555A	Case ref. no:	Y19-0726-FH	Case Officer	Katy Claw
Property Address:	Thornby Farm, Whiteways, Stowting, Ashford			
Proposals:	Erection of a two storey/single storey rear extension together with rear extension together with internal alterations and the addition of three Car parking spaces (<i>Revised proposals</i>)			
Application Type	Planning permission and LBC			
Agent:	Gary Tidwell Associates			
General Comments Operative Conditions?				
Listing / C/A?	Grade II, AONB			
Date Consult Received:	22/07/2019			
Date Comments Sent:	02/01/2020

1- General & Historic Building Description and Significance:

3-Comments:

4-Recommendations:

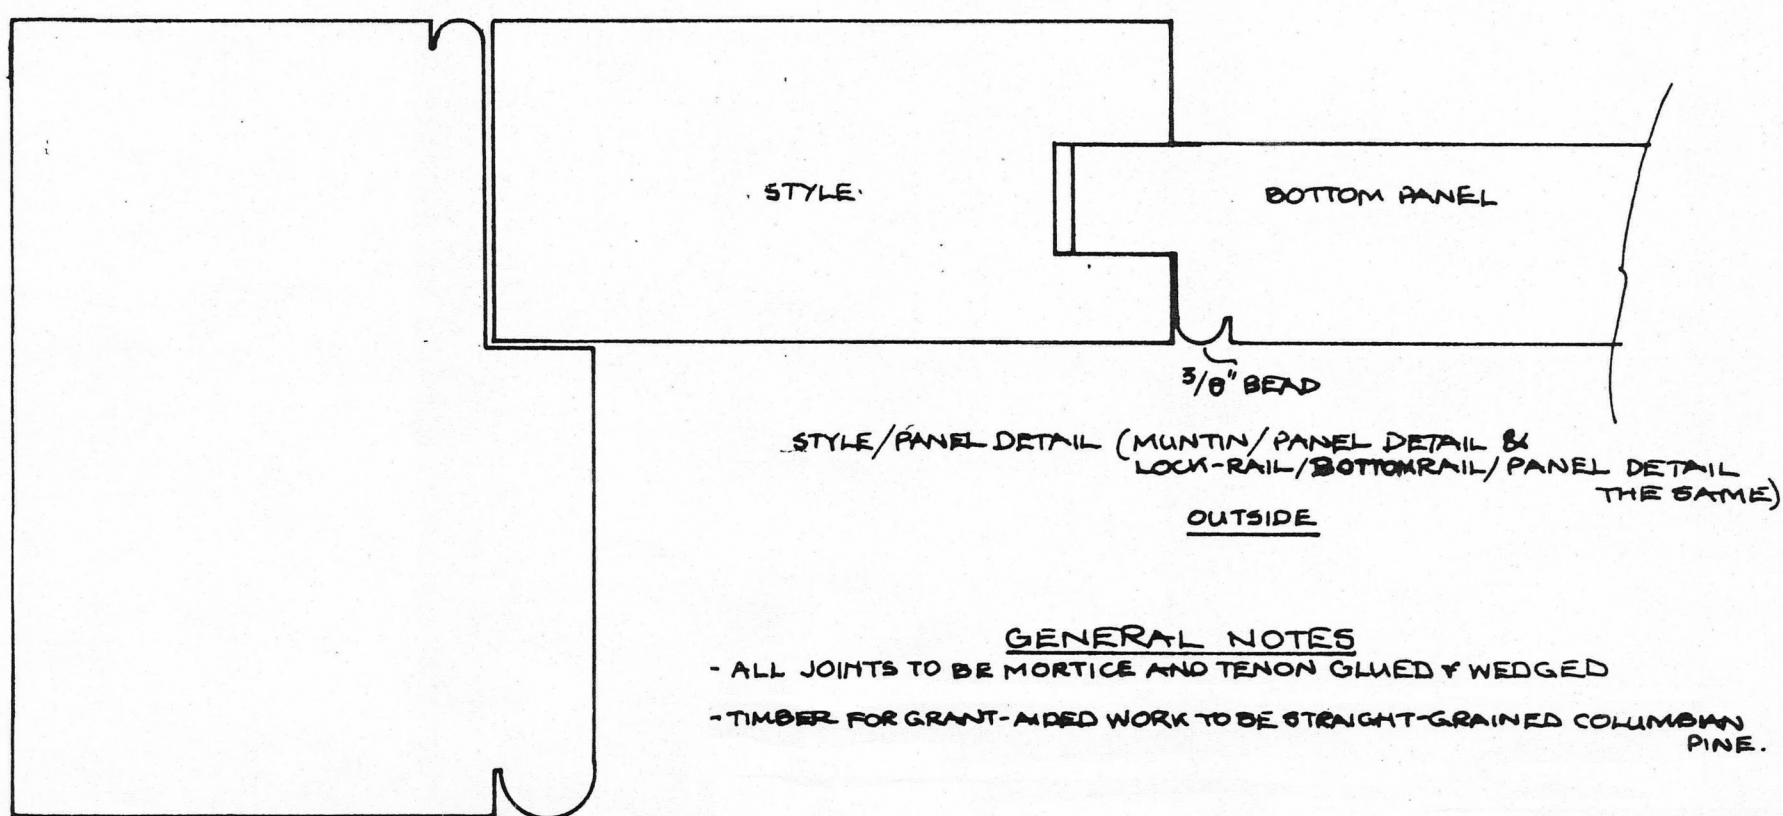
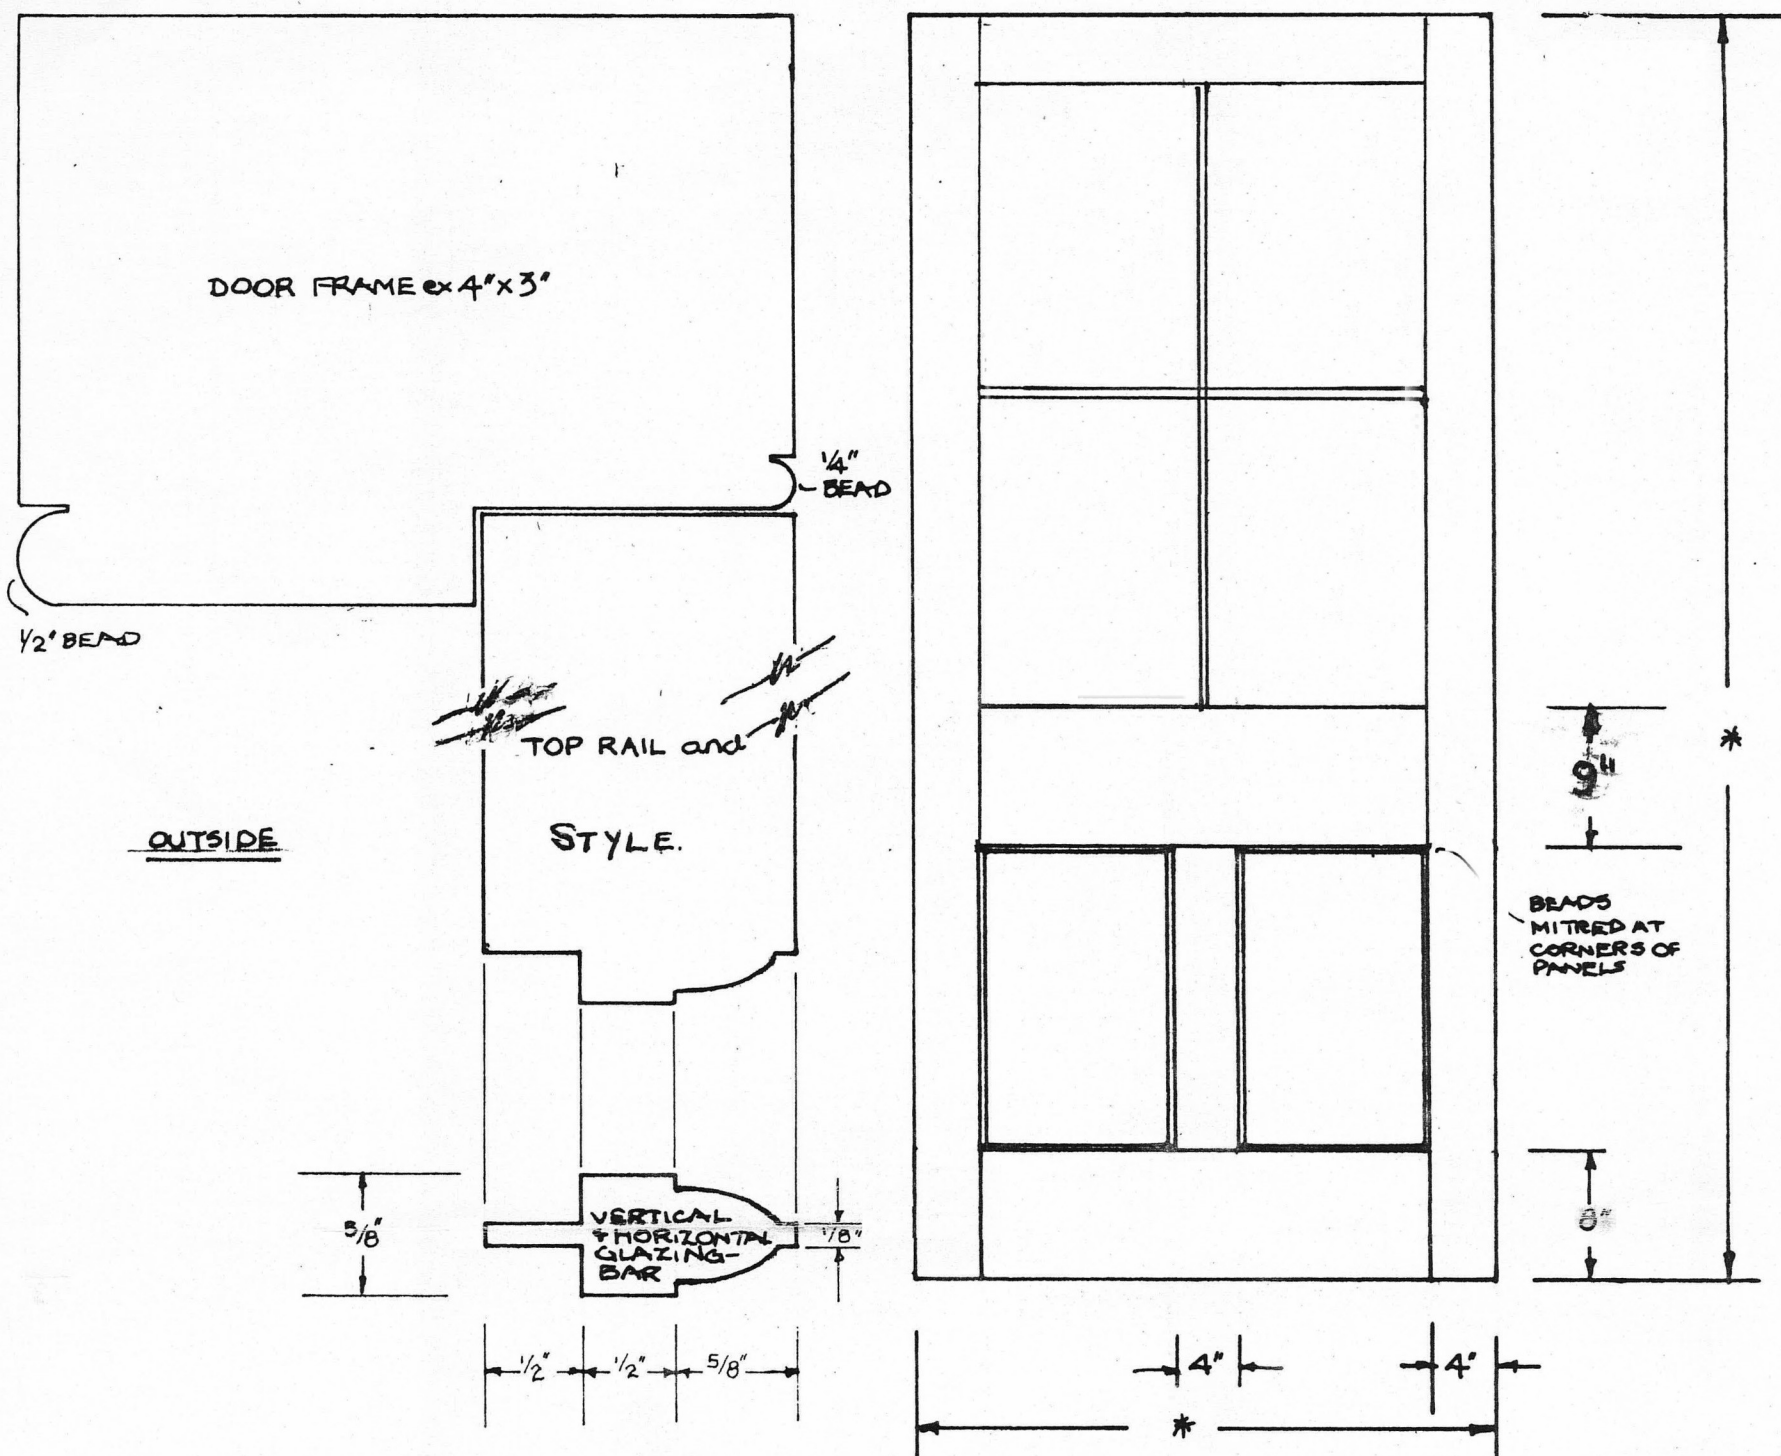
The fresh proposal to extend the lean-to storeroom to form a boot room is less successful, with the parapetted flat roof appearing as a rather unsightly “box” on the side elevation. The ground plan of this extension is however ok and I suggest the design could be improved were this element of extension also to have a pitched roof – similar to the kitchen extension and forming a lean to against the west wall of the house at the point where the existing extension is. If the eaves were lowered and the north end of the roof hipped, then this would avoid a clash with the existing first floor bathroom window on the west elevation.

The boarded door design here seems inappropriate and I suggest a half-glazed door of a design similar to that suggested for the east extension

I attach annotated sketch plans illustrating how these changes in the form might be arranged.

- East extension – amend door design to 1/2 glazed pattern (*see sketch*)
- Centre section – consider how to deal with the scar left by demolished utility room and consider an additional window here
- West kitchen extension – redesign roof as a simple hipped roof with ridge, omitting the centre flat roof area.
Reduce the eaves height by omitting the brick arches over the windows.
Indicate a downstand beam on the line of the original rear wall.
- Side west extension – consider re-designing this with a hipped tiled roof
Consider amending door design to half price (as per extension)

EARLY VICTORIAN

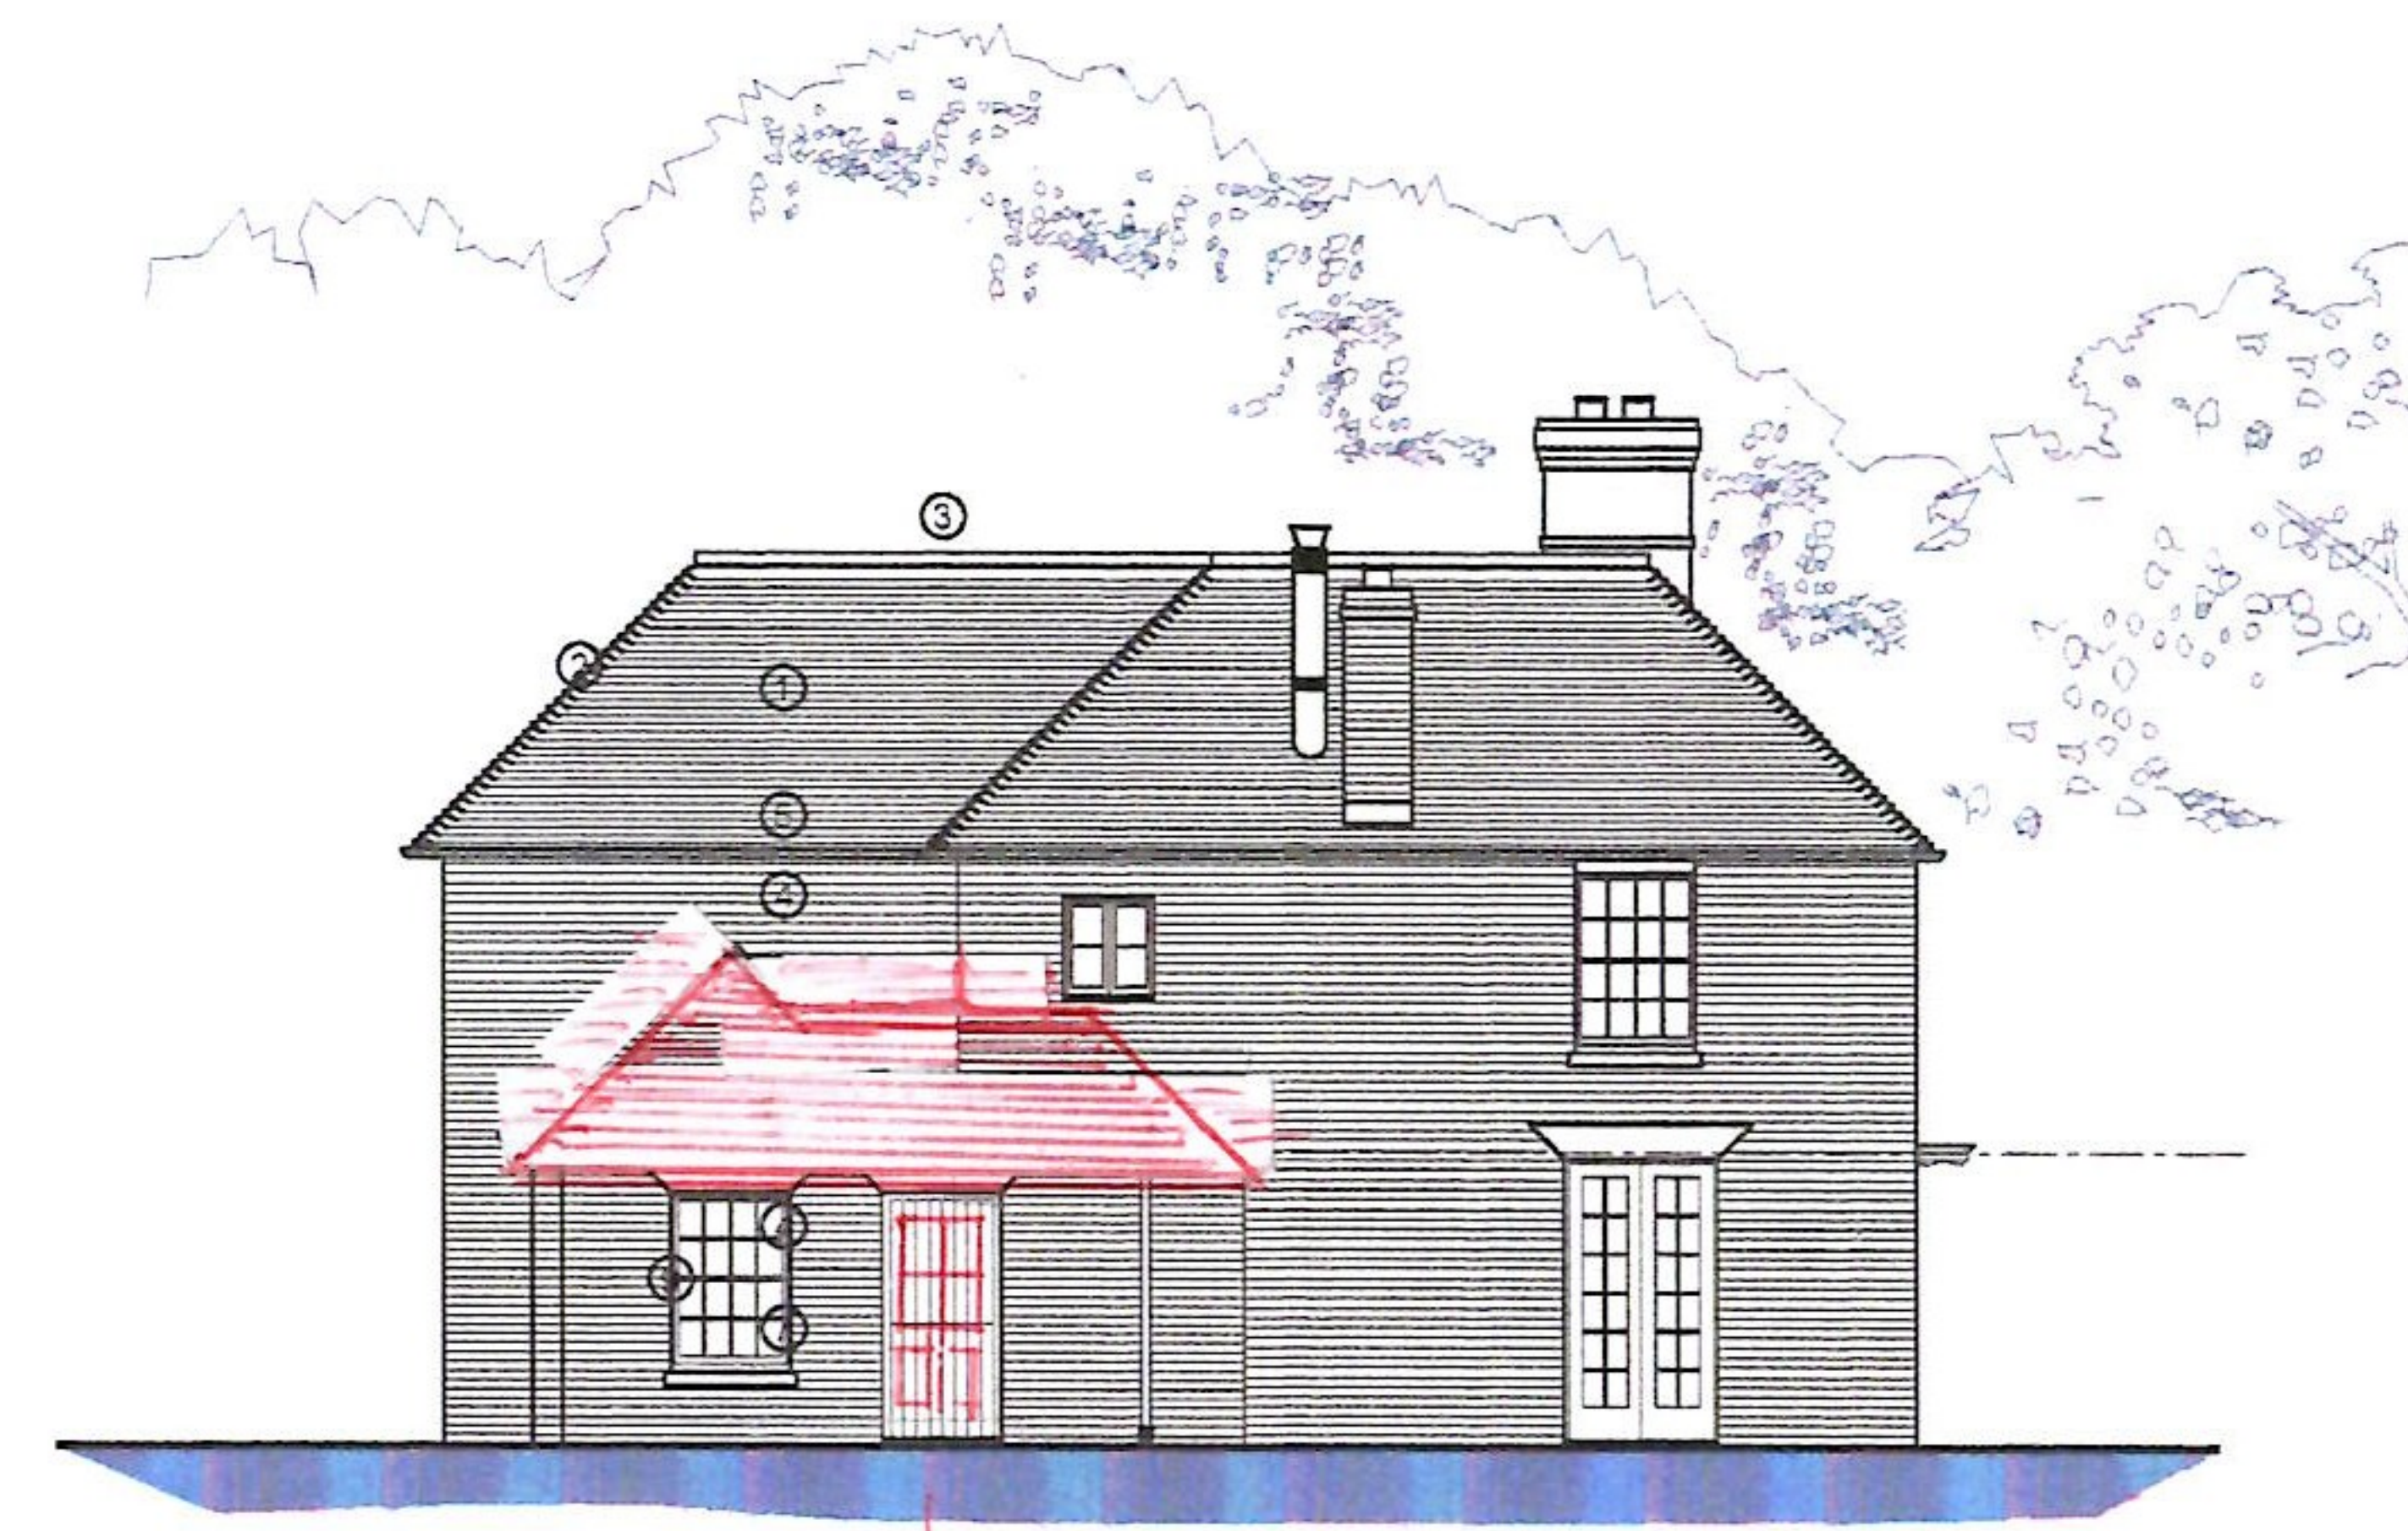
The design of the eastern two-storey extension was previously considered to be acceptable and the minor changes to the fenestration spacing have improved the design and are generally acceptable. The vertical boarded door seems of an inappropriate design for the house and I suggest a more traditional half-glazed door design would be more appropriate (*see enclosed drawing*)
